RFQ NUMBER
DEP13005

BENHAM GROUP 120-79

LINE	QUANTITY	UOP	CAT. NO.	ITEM NUMBER	UNIT PRICE	AMOUNT
0001	1	JB		962-73		
<p>***** ADDENDUM NO. 1 *****</p> <p>ADDENDUM ISSUED FOR THE BENHAM PROJECT TO DISTRIBUTE THE PRE-BID SIGN-IN SHEET FROM THE 08/28/08 MANDATORY PRE-BID MEETING, THE Q/A, THE REVISED SPECIFICATIONS, AND BID SCHEDULES RESULTING FROM THAT MEETING.</p> <p>BID DATE & OPENING HAVE BEEN EXTENDED FROM 10/01/08 TO 10/08/08 AT 1:30 PM</p> <p>PLEASE NOTE- IN ACCORDANCE WITH WV CODE 21-1D-5, BIDS FOR CONSTRUCTION CONTRACTS MUST CONTAIN A SIGNED PURCHASING AFFIDAVIT WITH THE BID. FAILURE TO SUBMIT THE SIGNED PURCHASING AFFIDAVIT WITH THE BID SHALL RESULT IN DISQUALIFICATION OF THE BID.</p> <p>***** NO OTHER CHANGES *****</p> <p>RECLAMATION: RESTORATION OF LAND</p>

BENHAM GROUP 120-89
ADDENDUM #1**CHANGES TO SCOPE OF WORK AND TYPICALS**

OFFICE OF SPECIAL RECLAMATION	
VALLEY FILL FACE REPAIR	
SCALE:	DRAWN BY:
DATE:	PROJECT NO.:

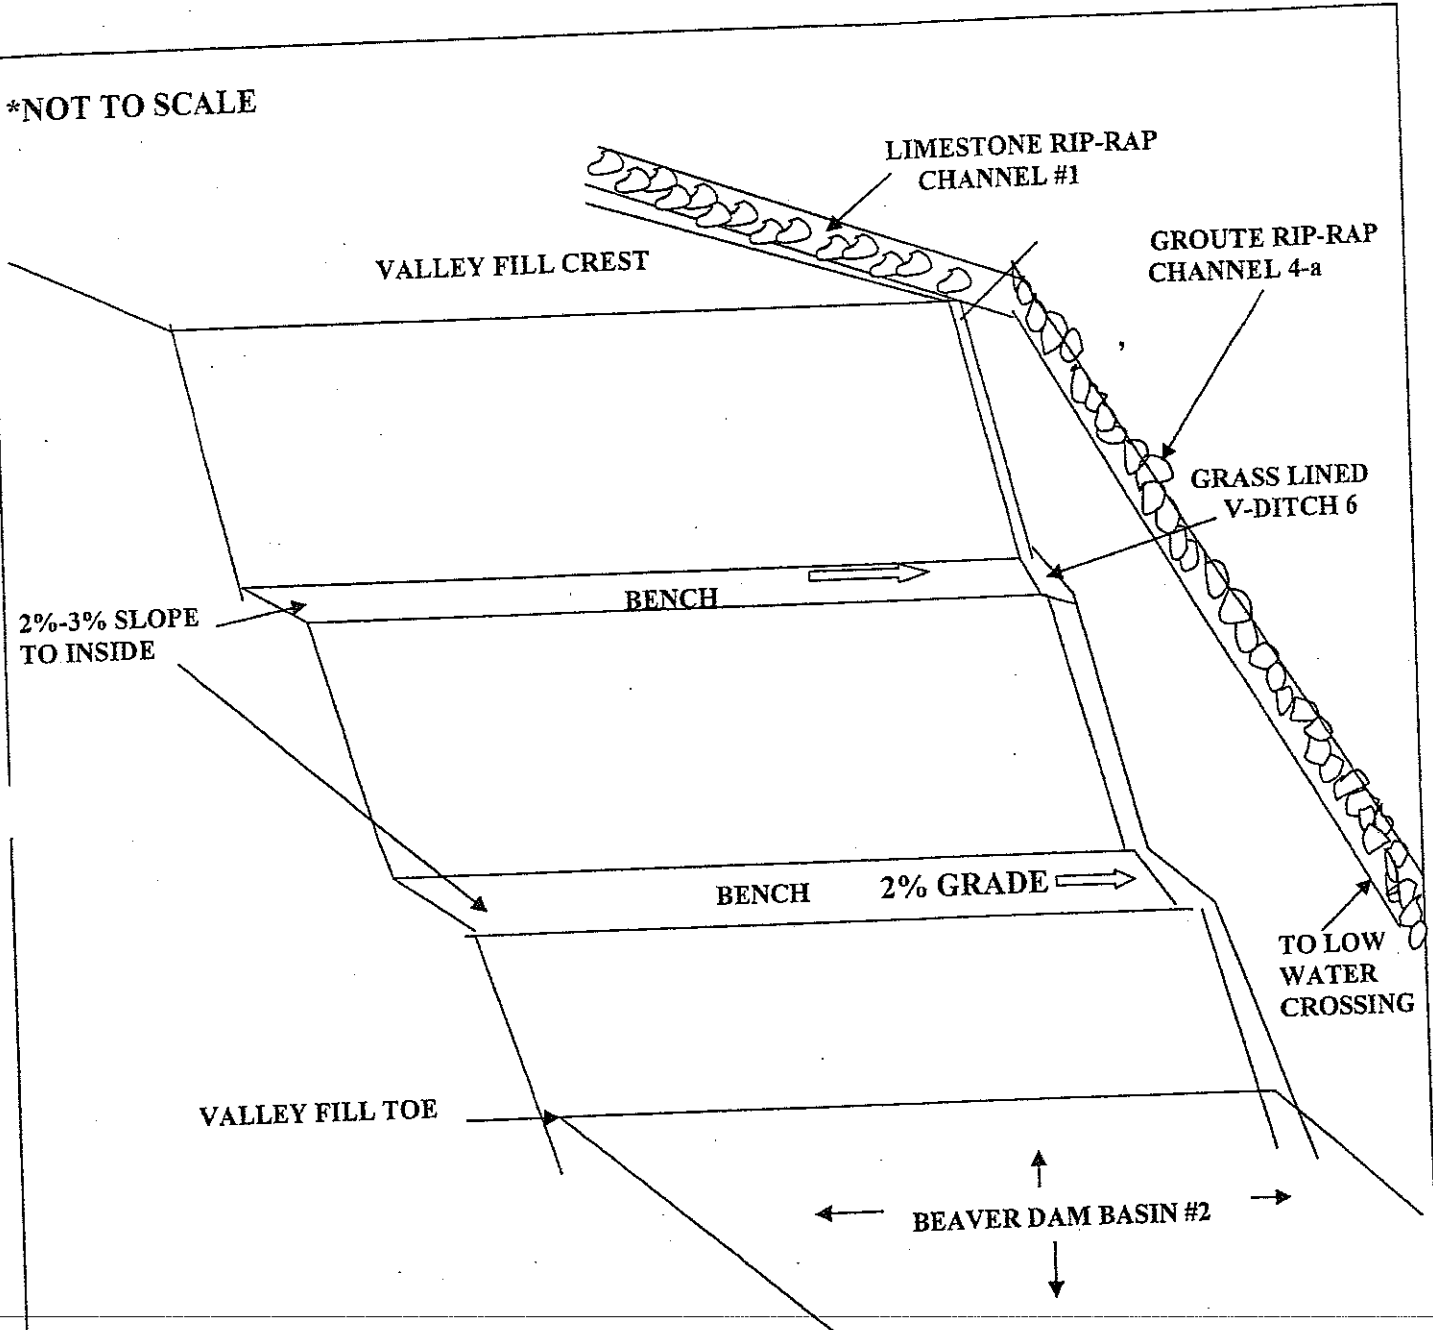
- 23) On page 43, the VALLEY FILL FACE REPAIR typical has been changed to show the grass lined V-ditch #6 to be along the edge of the fill. Also changed is the GROUTED RIP-RAP CHANNEL #4A. This ditch will continue to the low water crossing and not into the beaver pond. (A new typical is attached.)
- 24) On page 49, FINGER DRAIN TYPICAL, changes were made to show length of finger drains to be twenty-five feet (25') long. (A new typical is attached.)
- 25) On page 55, SUMP/CULVERT/ALKALINITY CELL #3 typical was changed to show top width and height of limestone check dam #2 (AA at the top). (A new typical is attached.)
- 26) On page 56, SUMP AND 24" CULVERT, the note in the middle referring to the sump being lined was deleted. (A new typical is attached.)
- 27) On page 59, SLUDGE PUMP LINE ATTACHMENT, the 6" HDPE DR11 PIPE changed to read 6" HDPE DR17 PIPE. (A new typical is attached.)

TYPICAL V-DITCH

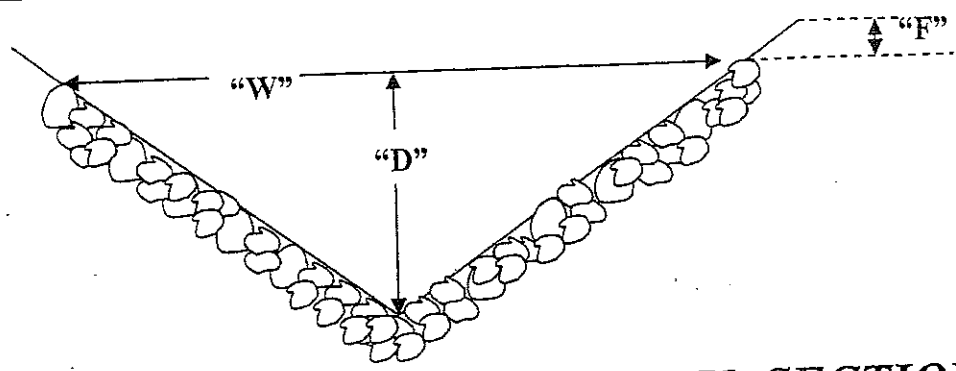
- 12) A new sheet is attached referring to the V-DITCH chart on page 45. The DEPTH "D" of ditches #3, #4, #5, and #6 should be 1' instead of 2'. On the chart, in the note at the bottom, it states that "Ditches #1 and #2 will be standard limestone rip-rap." Delete "#2" from this line and add new line "Ditch #2 will be limestone of 3" to 5" in diameter." (A new typical is attached.)

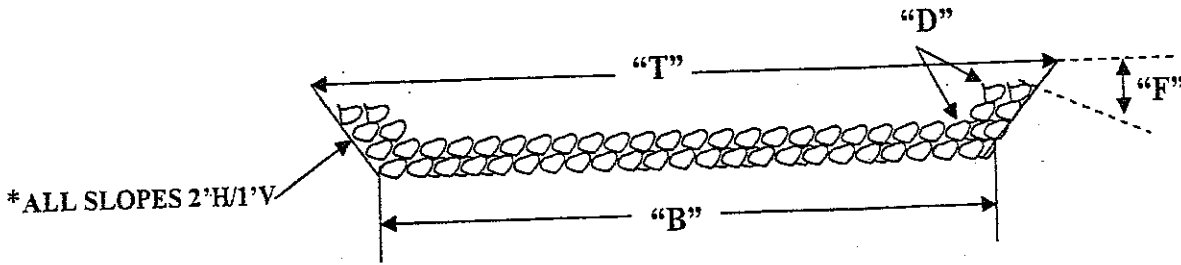
- 20) On page 20, change the second "item 17.3" to "item 17.4".
- 21) On page 48, Channel #4a should be lined with "grouted limestone" rather than "grouted sandstone". (A new typical is attached.)

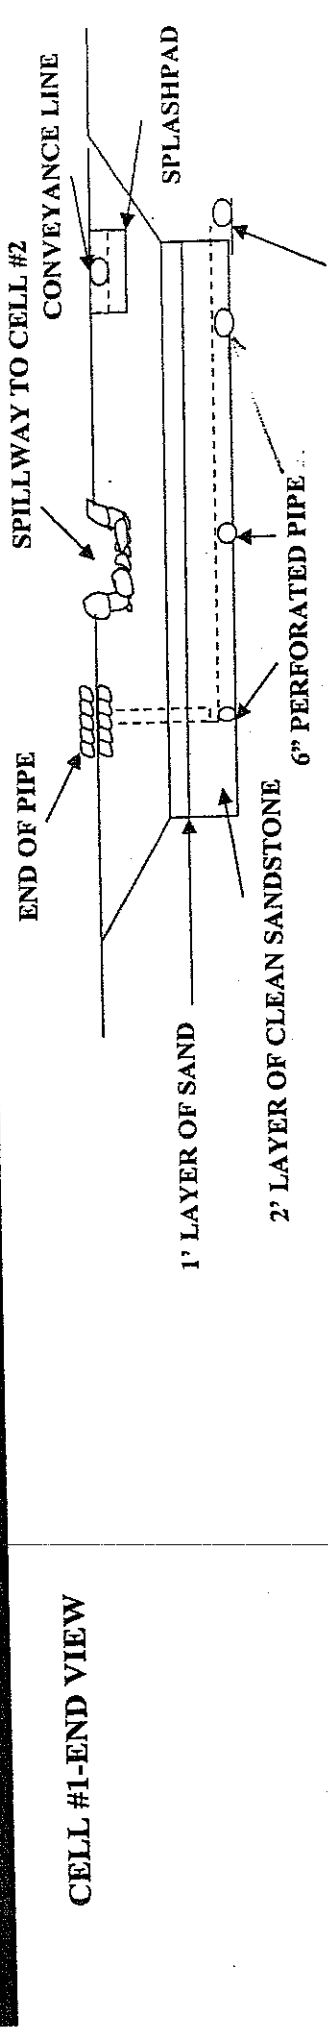
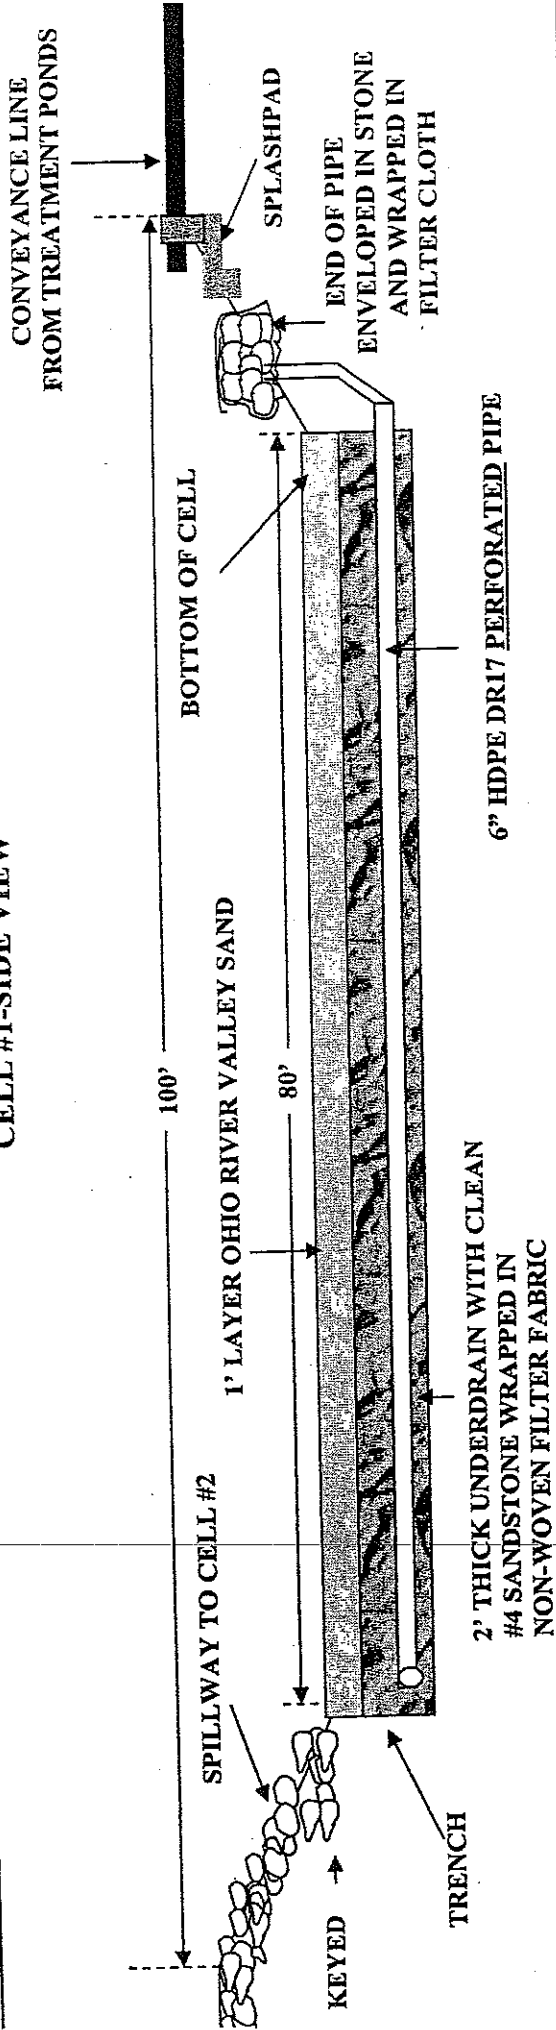
- 8) On page 15, Item #19 refers to ...“entrenched one foot (1') thick layer of”. This item should state that the “complete system of pipes, stone, sand, and fabric will be installed in one trench on the bottom of the drying cell. The typical, SLUDGE CELL#1 X-SECTION, on page 53, has been changed to show this installation. (A new typical is attached.)

OFFICE OF SPECIAL RECLAMATION	
DRYING CELLS TYPICAL	
SCALE:	DRAWN BY:
DATE:	PROJECT NO:

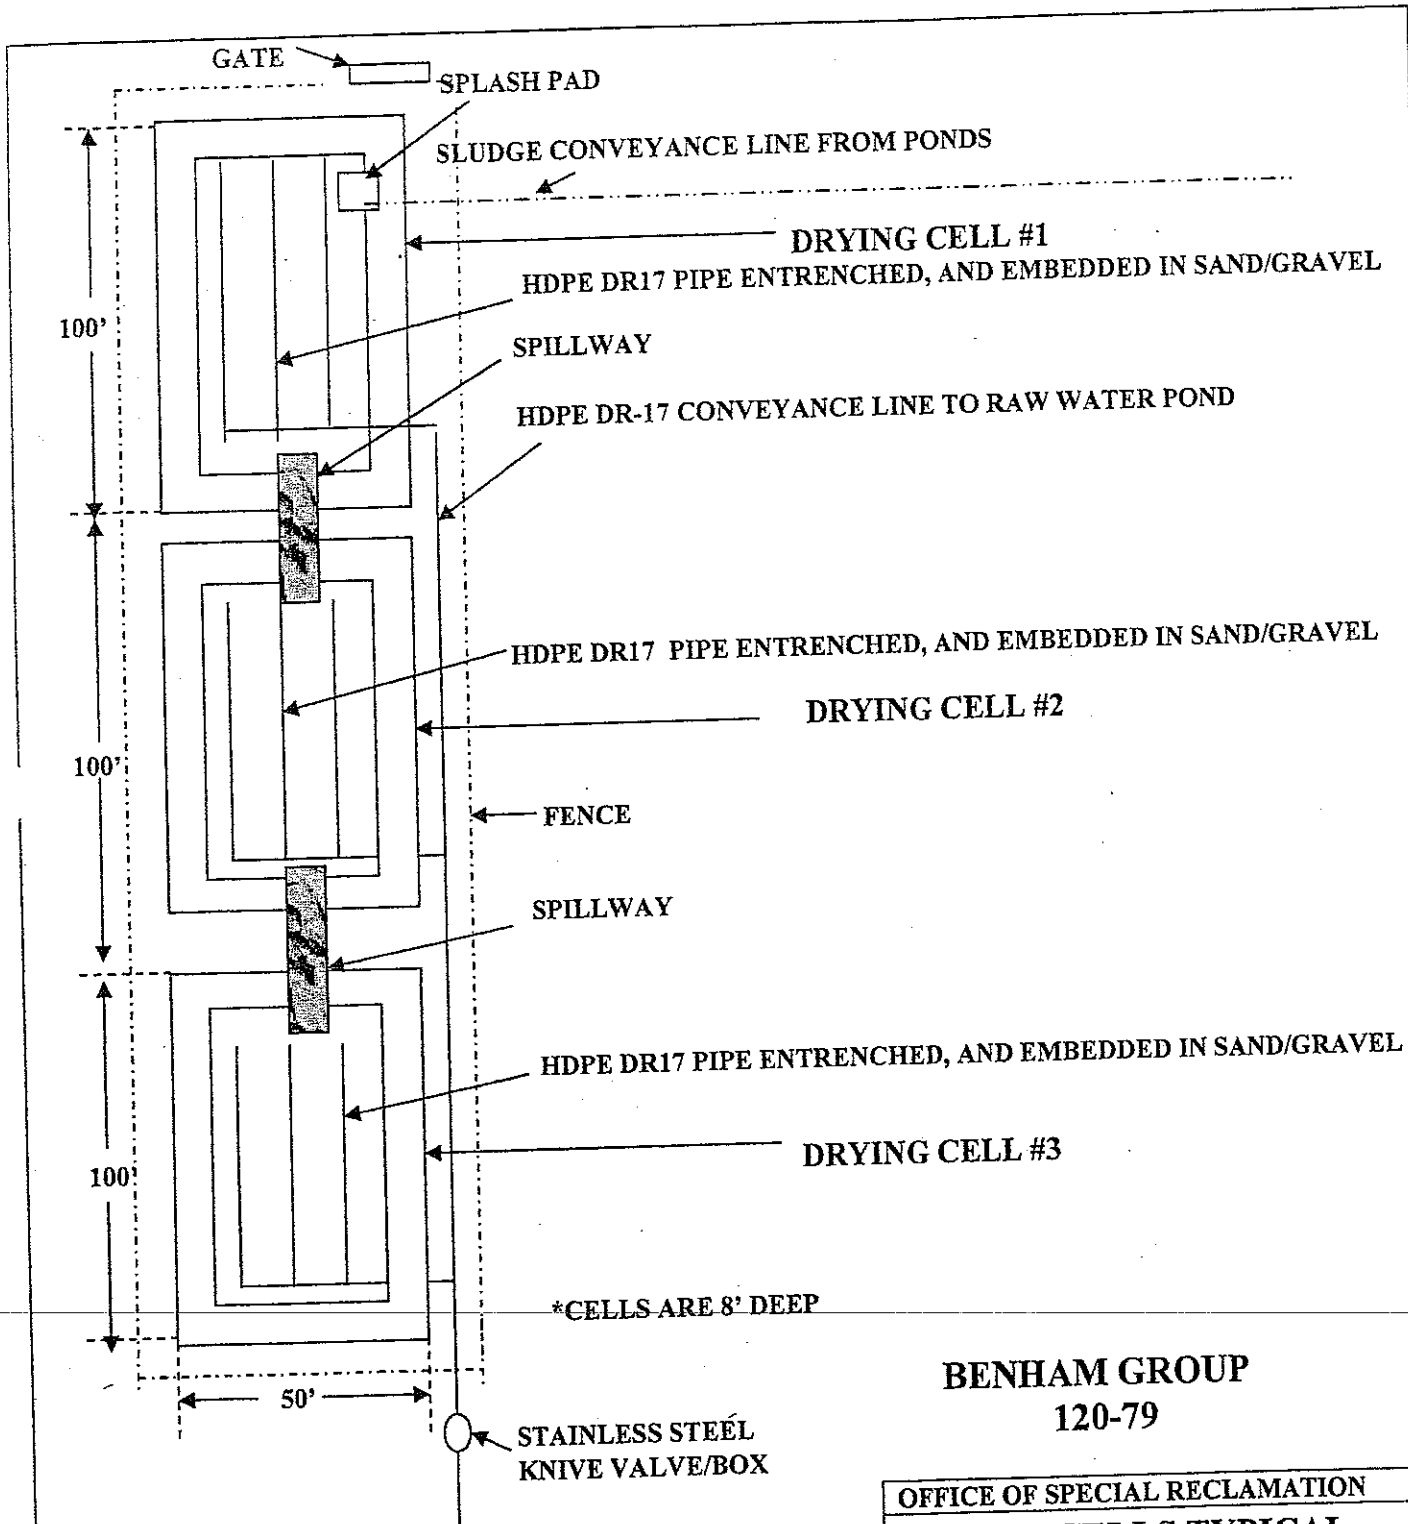
- 9) On page 15, Item #20, change reference ...“SCR 35 perforated underdrain”...to read ...“HDPE DR 17 perforated underdrain. The DRYING CELL TYPICAL, on page 54, has been changed to show the installment. (A new typical is attached.)

OFFICE OF SPECIAL RECLAMATION SUMP/CULVERT/ALKALINITY CELL #3	
SCALE:	DRAWN BY:
DATE:	PROJECT NO:

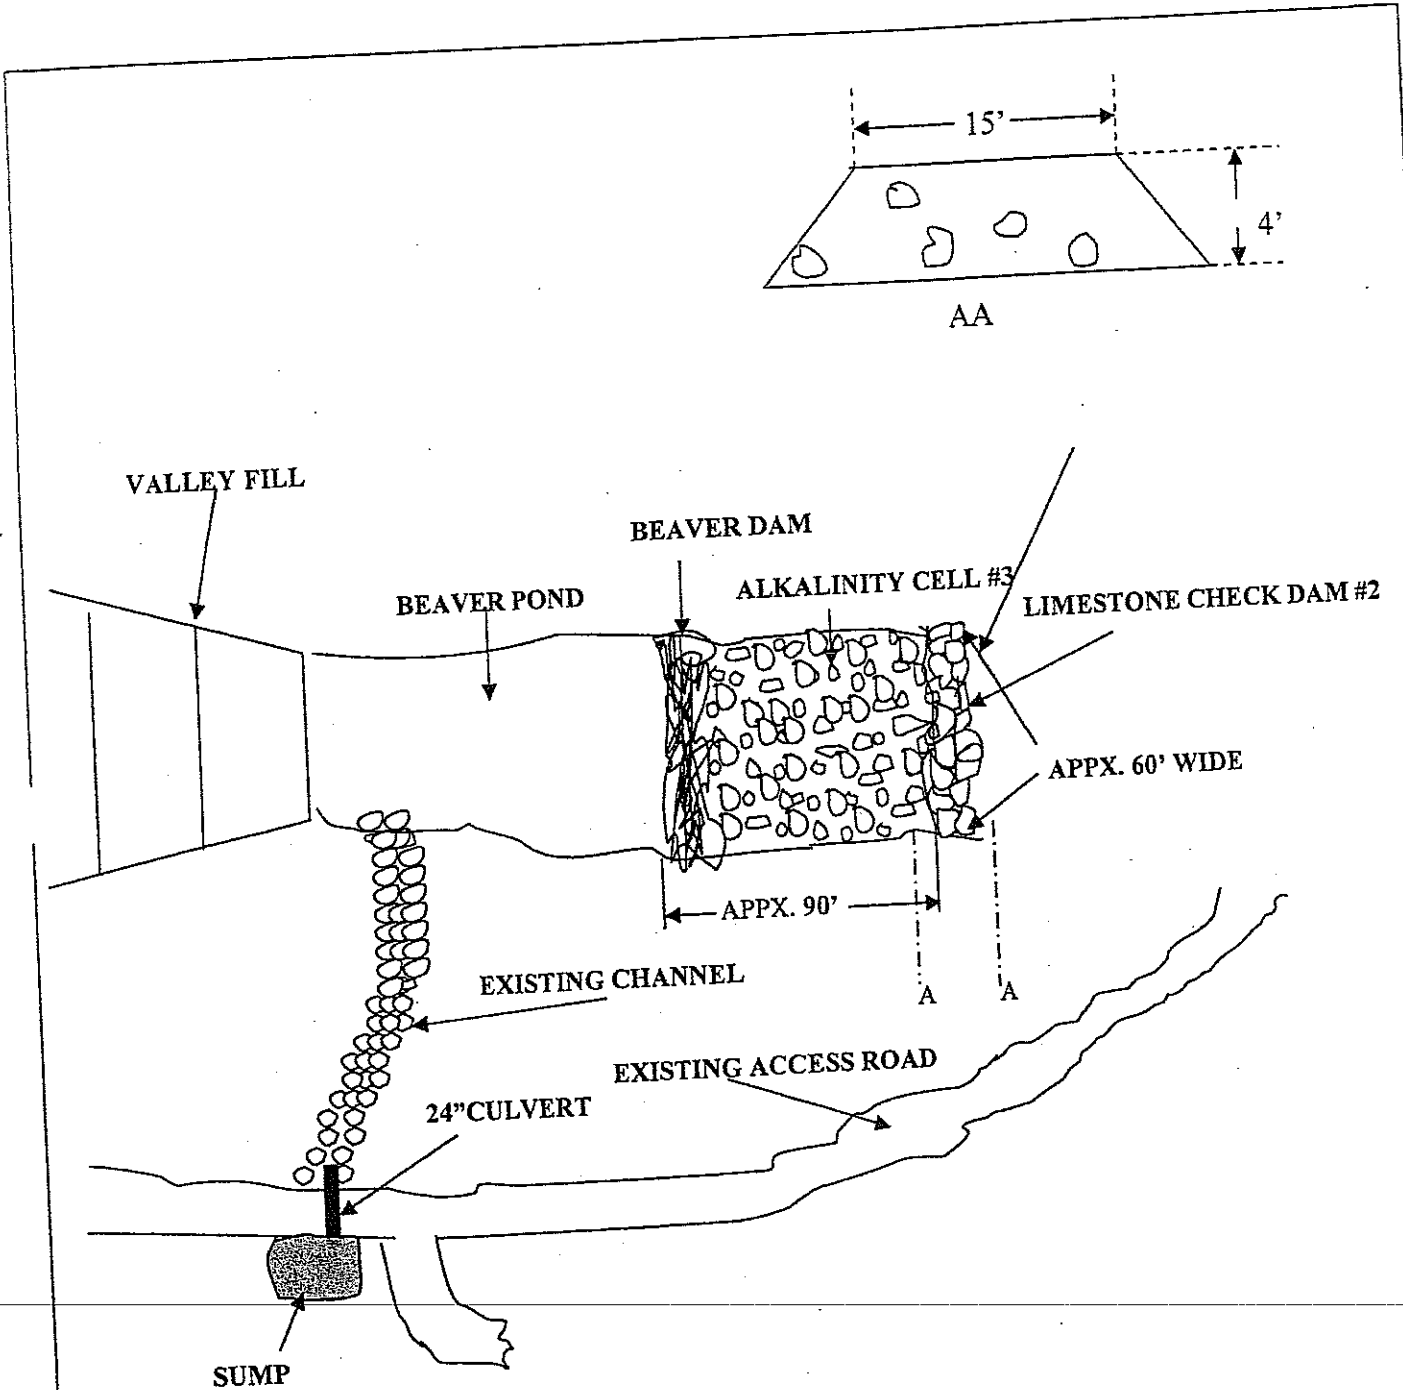
- 22) On page 16, Item #21, remove the lines "Sump will be equipped with a HDPE "Poly-Flex liner with a sixty (60) mil thickness, or equivalent, which shall be fused on site and not leak. The liner shall cover the entire inside of the sump and be anchored in at the top." Also, there will be no reference to cost of the liner on this item. The typical, SUMP/CULVERT/ALKALINITY CELL on page 55, and the SUMP AND 24"

CULVERT typical on page 56, have also been changed to show that the sump will not be lined. (A new typical is attached.)

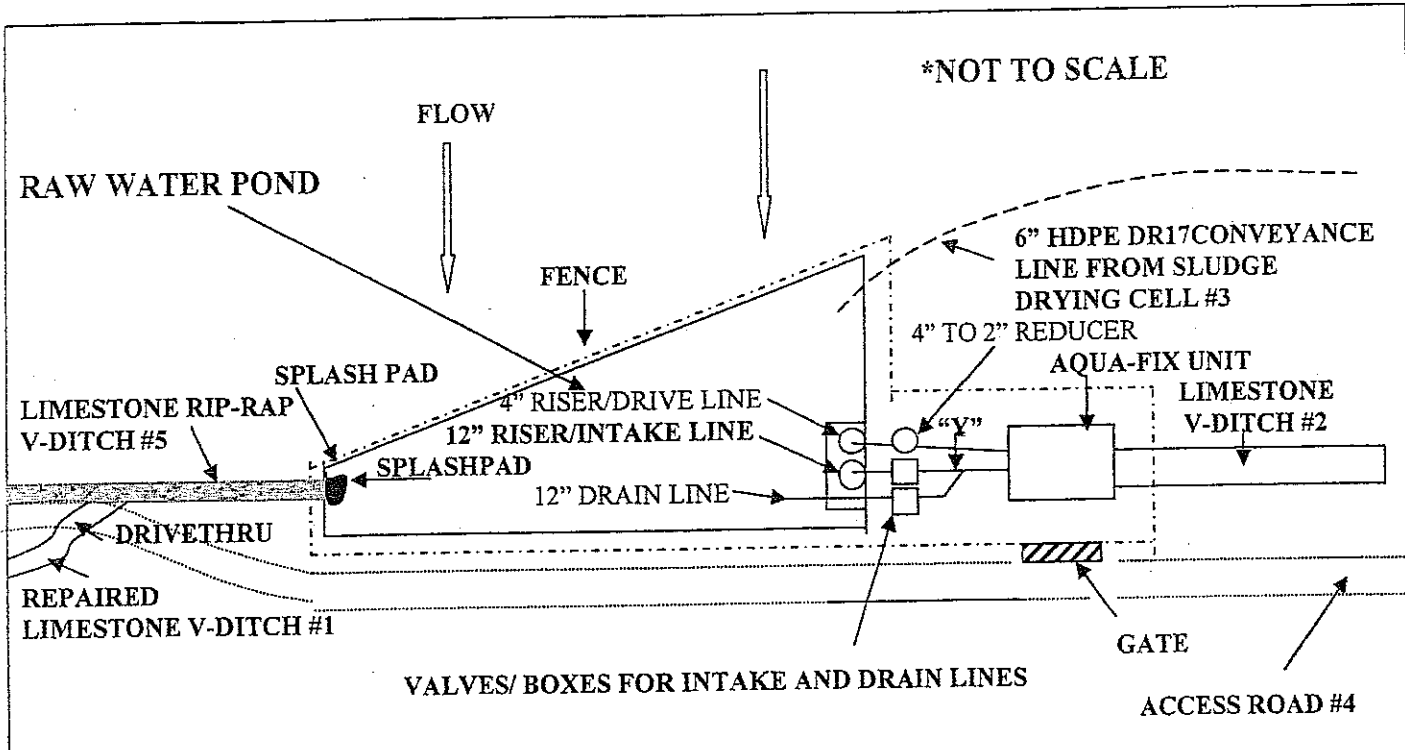
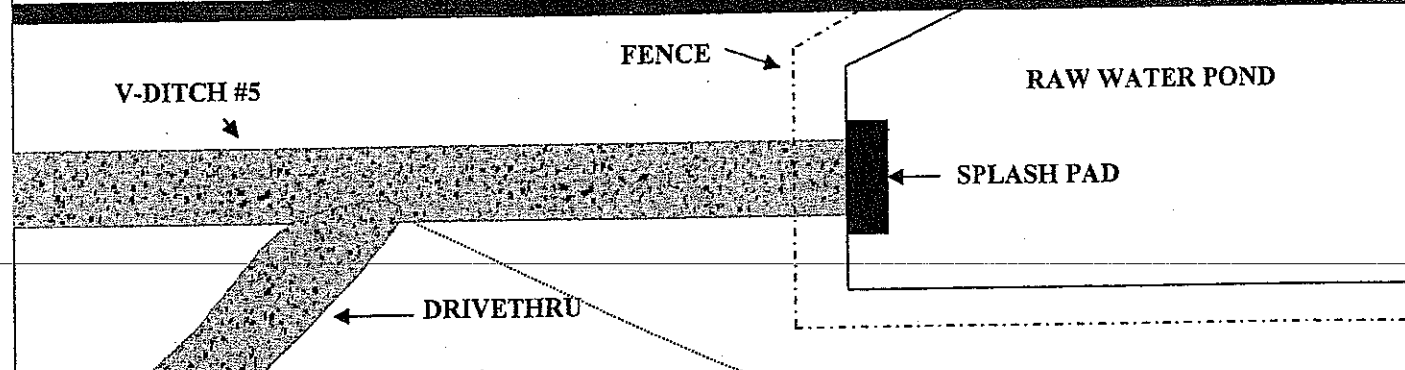
- 7) Page 78, “RAW WATER POND TYPICAL” , and page 79, “RAW WATER POND STAND PIPE ANCHOR PAD TYPICAL”, have been changed to show only two (2) risers and one (1) drain line. Also, on the RAW WATER POND TYPICAL, change “SPLAHPAD” to read “SPLASHPAD”. On the RAW WATER POND STAND PIPE ANCHOR PAD TYPICAL, change.... “ONE 12” AND ONE 4” SCHEDULE 40 PVC RISERS” HDPE DR17 RISER ...to read ...ONE 12” HDPE DR 17 RISER AND ONE 4” PVC RISER”. Note that the typical also shows the dike wall continuing past the anchor pad and the rebar in the anchor pad is shown to run horizontal as well as vertical. (New typicals have been attached.)
